Summary of Applicant's Case put Orally - Landscape, Design, Archeology and Heritage hearing and associated appendices

TR020002/D8/ISH4

MANSTON AIRPORT DEVELOPMENT CONSENT ORDER APPLICATION
APPLICANT'S WRITTEN SUMMARY OF ORAL SUBMISSIONS PUT AT ISSUE SPECIFIC HEARING 4 ON
LANDSCAPE, DESIGN, ARCHAEOLOGY AND HERITAGE

3 JUNE 2019

MANSTON AIRPORT DEVELOPMENT CONSENT ORDER
 LANDSCAPE STRATEGY
 REGULATION 5 (2) (o)
 THANET DISTRICT COUNCIL

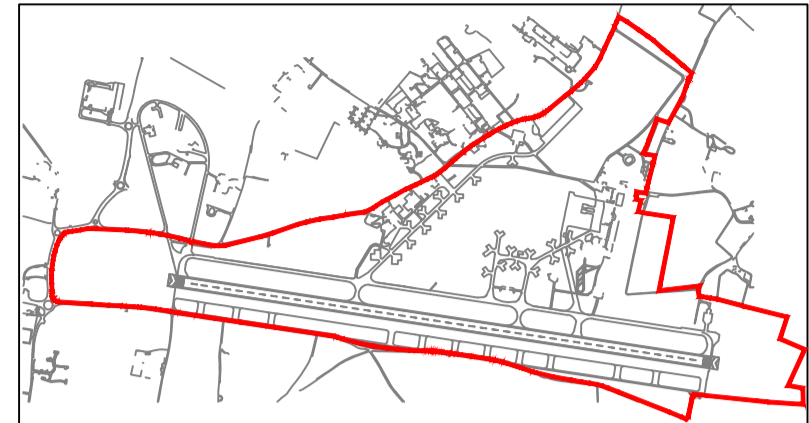
- 2.24 The Applicant highlighted that hedgerows along the northern boundary at the western end of the site, and along an internal access road to the south of this, were not illustrated on the Landscape Strategy Plans, but will be retained. The Landscape Strategy Plans have been updated to indicate this and are submitted as Appendix 1 to this document.

A	Existing hedges added	NJ	CT	CJ	June 19
Rev	Description	By	Ckd	Apr	Date

Title **LANDSCAPE STRATEGY DETAILED PLAN 1 OF 4**

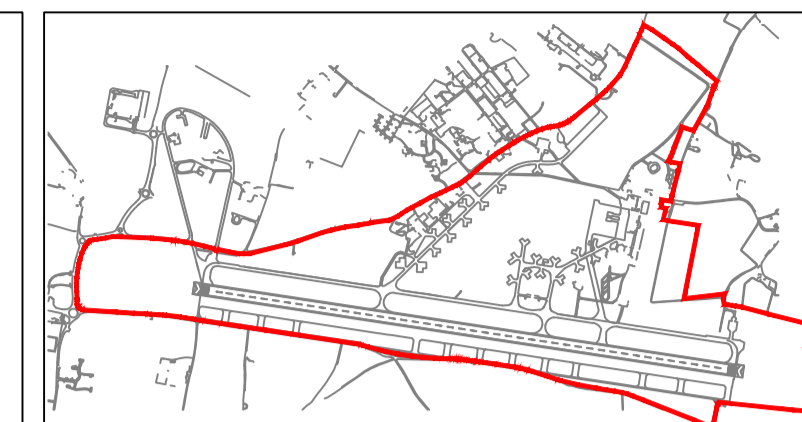
- 2.25 The Applicant further highlighted that the southern hedgerow may need to be reduced in length, as the eastern end of it lies within the glide path from a western approach and an assessment of the hedgerows height needs to be undertaken in relation to this. Surveys of this feature will be carried out prior to commencement of construction, once access to the site is available. The Landscape Masterplan will need to take into account any 'features of interest' or ecological value in the final version of the masterplan. The final masterplan as

Rev	Description	NJ	CT	CJ	June 19
A	existing hedgerows added

Existing hedgerow to be assessed in relation to the Glidepath sensitive area. Should conflict arise, a proportion of the eastern end of the hedgerow would be removed

Title **LANDSCAPE STRATEGY DETAILED PLAN 4 OF 4**

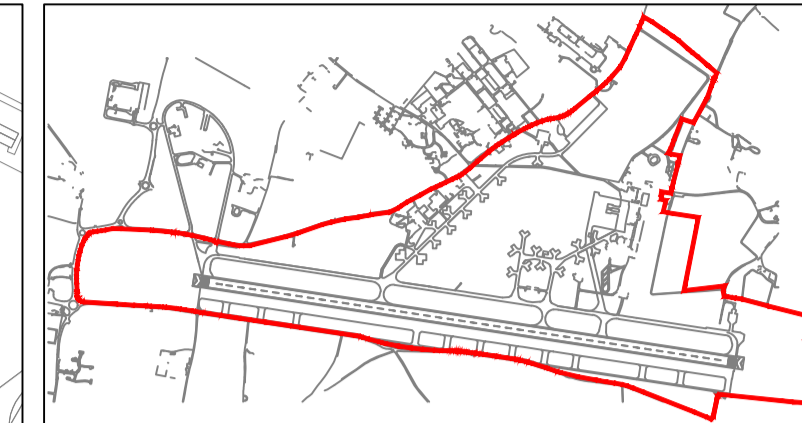
- 2.2.1 Section B of the Design Guide [REP4-024] now indicates that bunding would be placed along the western boundary of the Northern Grass Area and these earthworks are now illustrated on the Landscape Strategy Plans submitted at Deadline 8.

Rev	Description	NJ	CT	CJ	June 19
A	Contours added to NW mound
